SUBJECT: CYCLE 9 RELOAD AND SINGLE LOOP OPERATION

Re: Quad Cities Nuclear Power Station, Unit 2

Amendment No. 95  
License No. DPR-30

SAFETY EVALUATION BY THE OFFICE OF NUCLEAR REACTOR REGULATION  
SUPPORTING AMENDMENT NO. 95 TO FACILITY OPERATING LICENSE NO. DPR-30

Figure 2.1-1

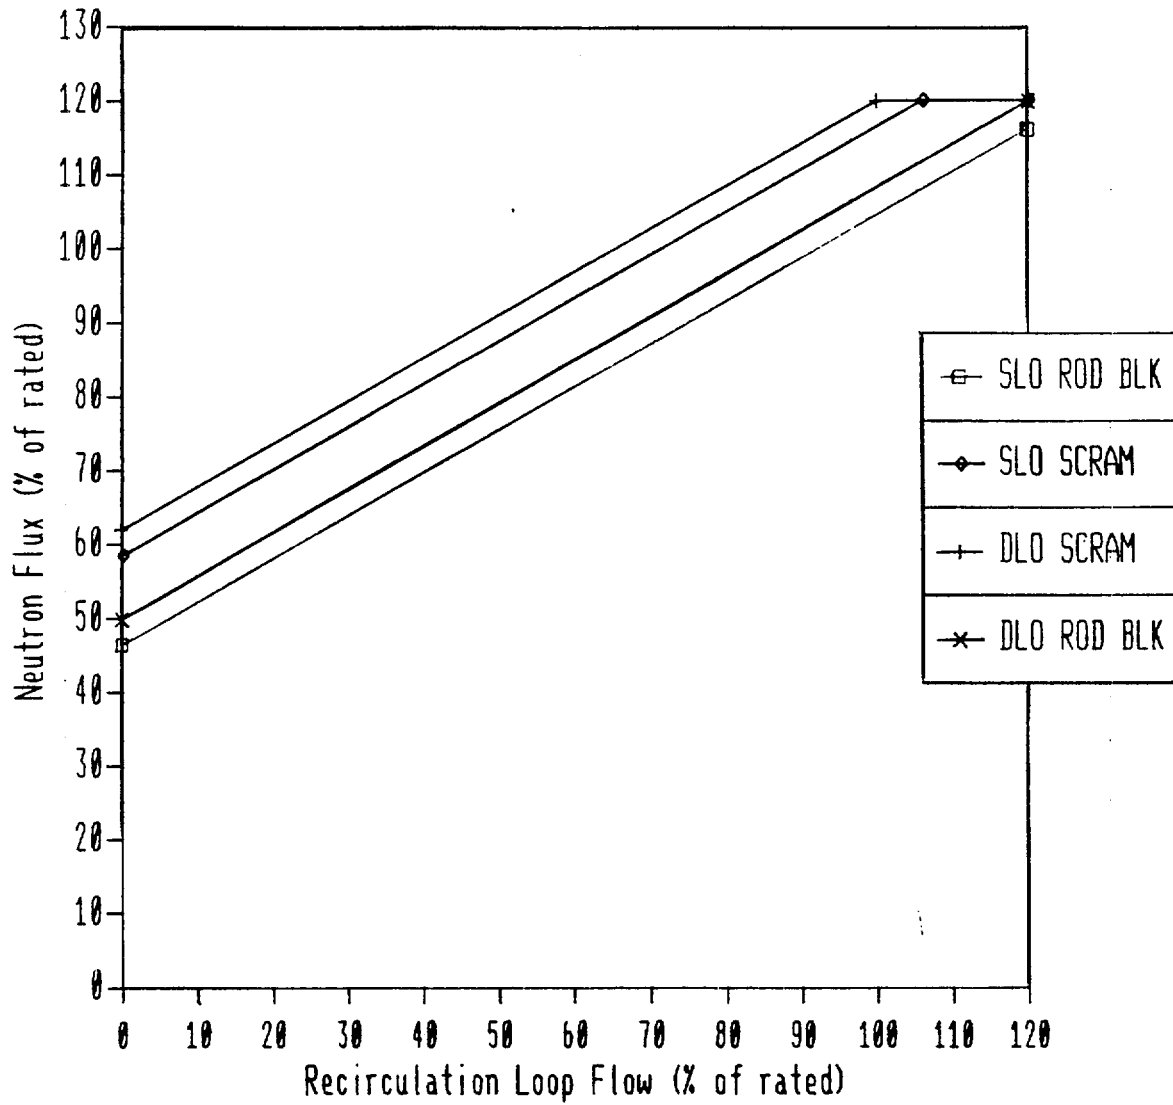
4. Revision of Figure 2.1-1. This incorporates SLO and DLO scram and rod block settings and is acceptable.
5. Revision of Figure 2.1-3 to reflect the extended load limit analysis previously implemented. This is acceptable.

Figure 3.5-1  
Sheet 1 of 6

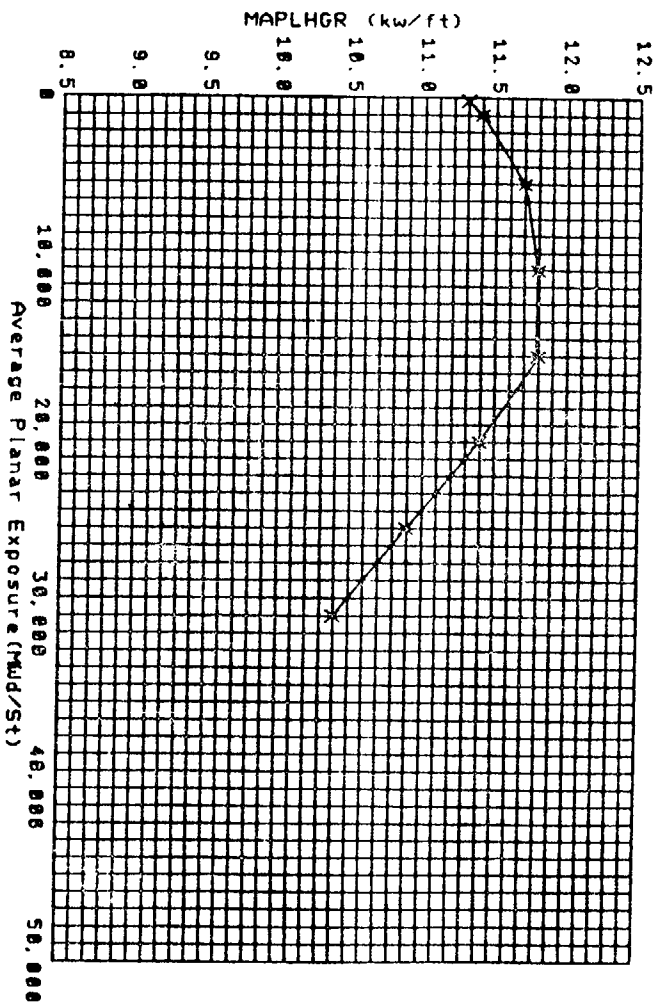
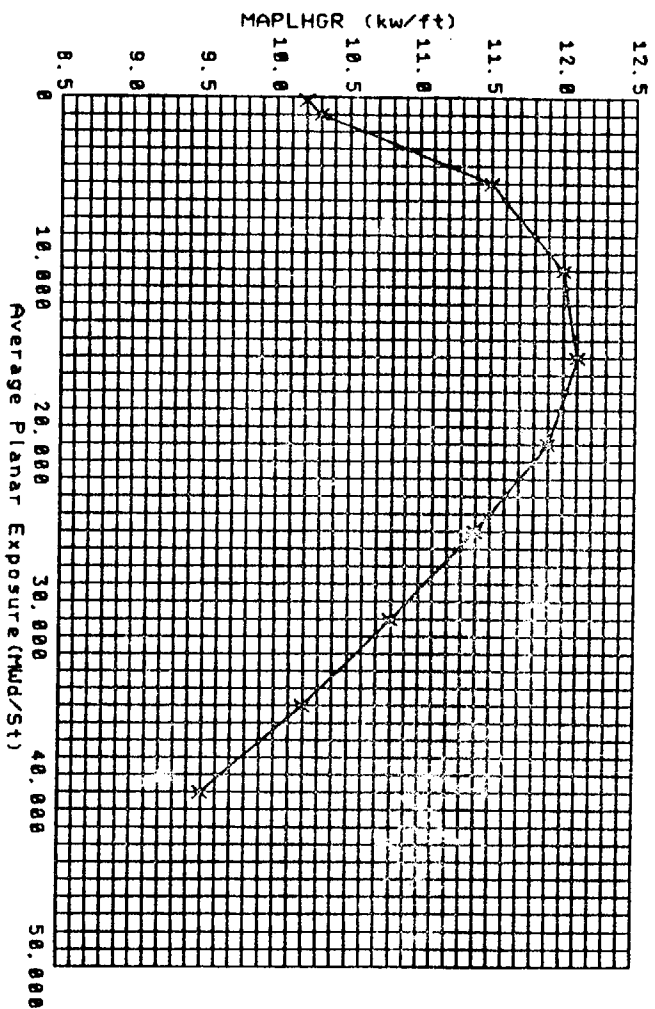
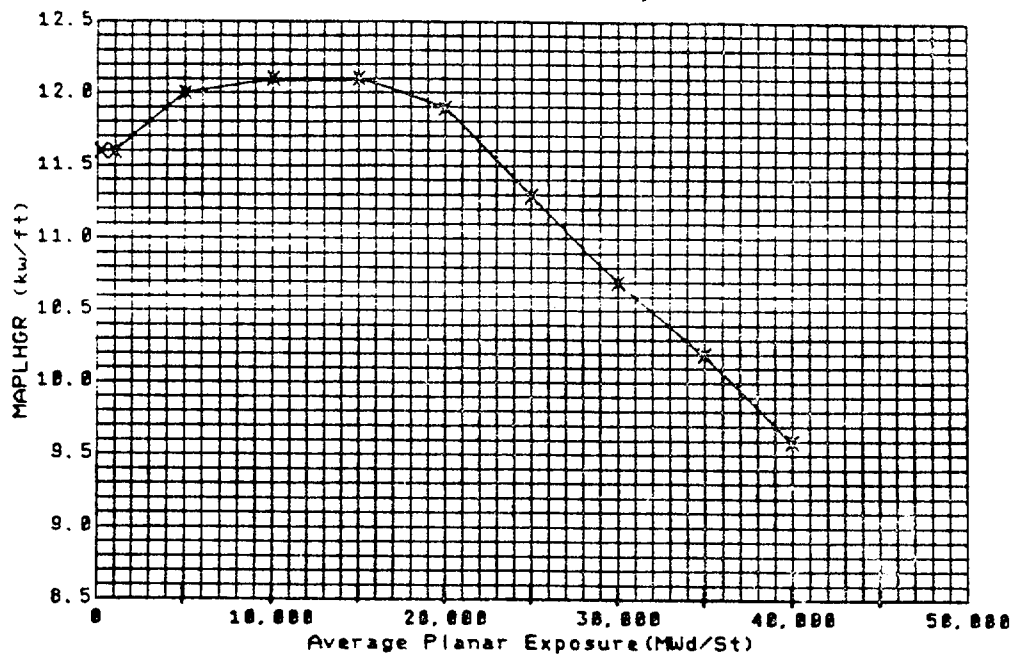
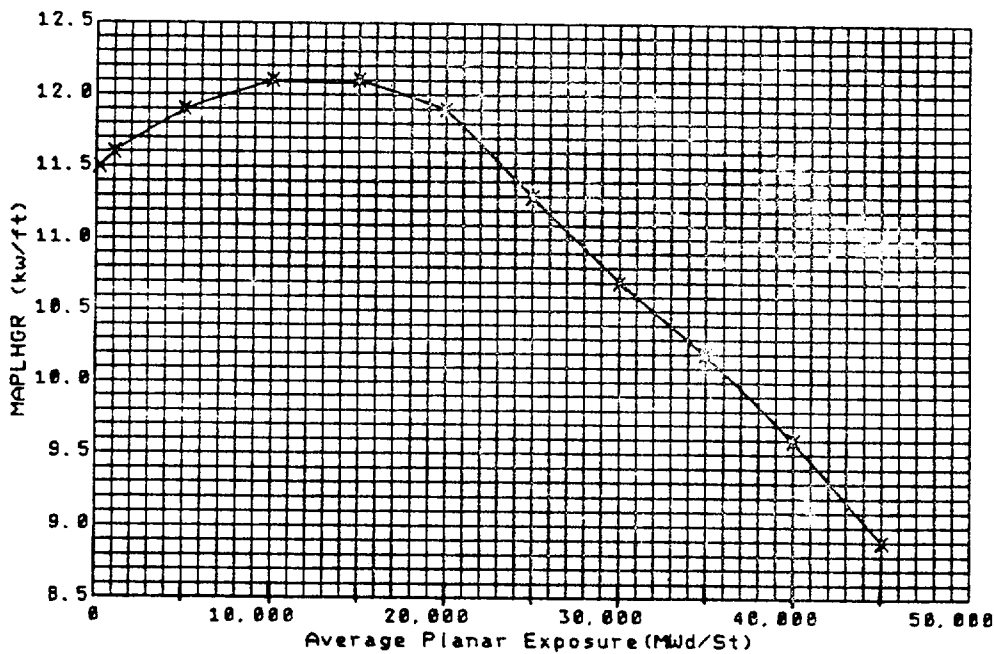
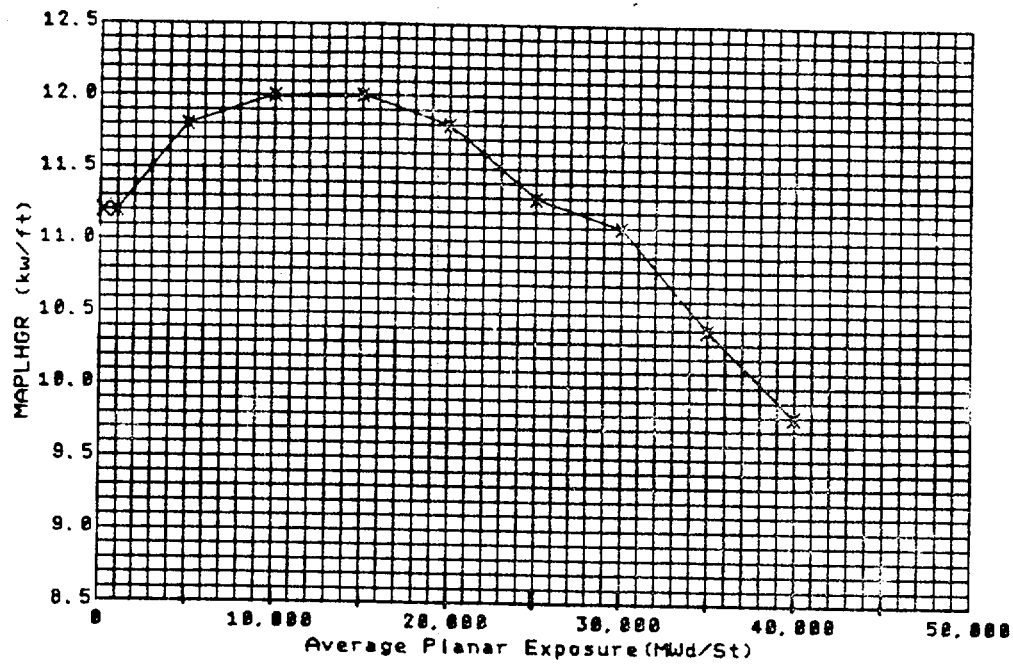
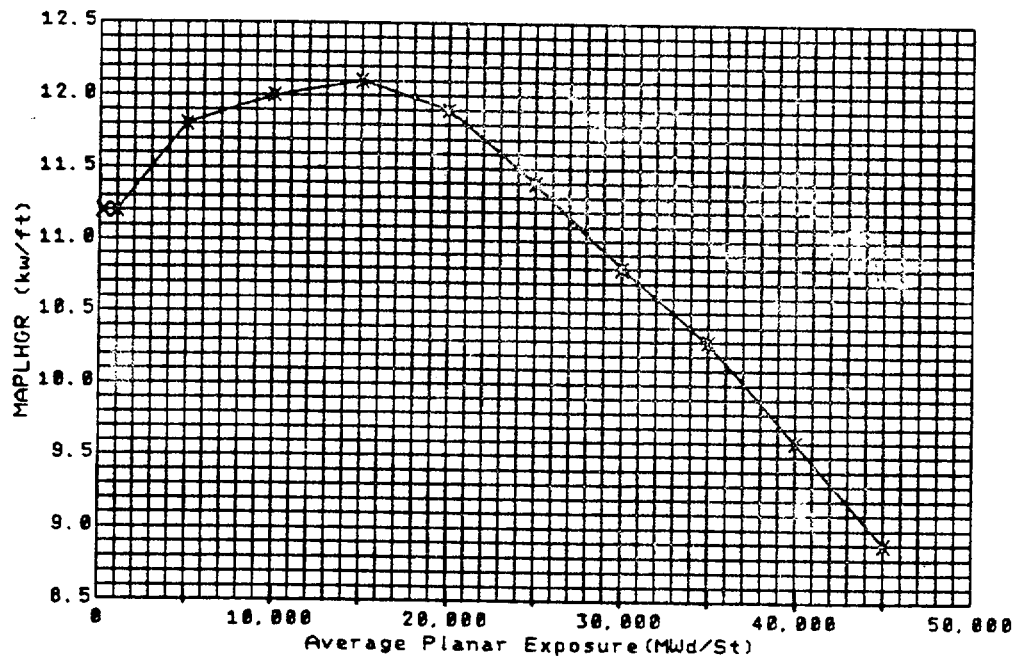
8. Figure 3.5-1, sheets 1-6, "MAPLHGR vs. Average Planar Exposure", were replotted and rearranged. Fuel types 8DRB265L, 8D250 and 8D262 were deleted. Fuel types BP8DRB299L and BP8DRB299 were added. The average planar exposure for fuel type P8DRB282 was extended to 40,000 MWD/STU. The deleted fuels are no longer used and the added fuel is part of the reload listed and approved in GESTAR II. This is acceptable.
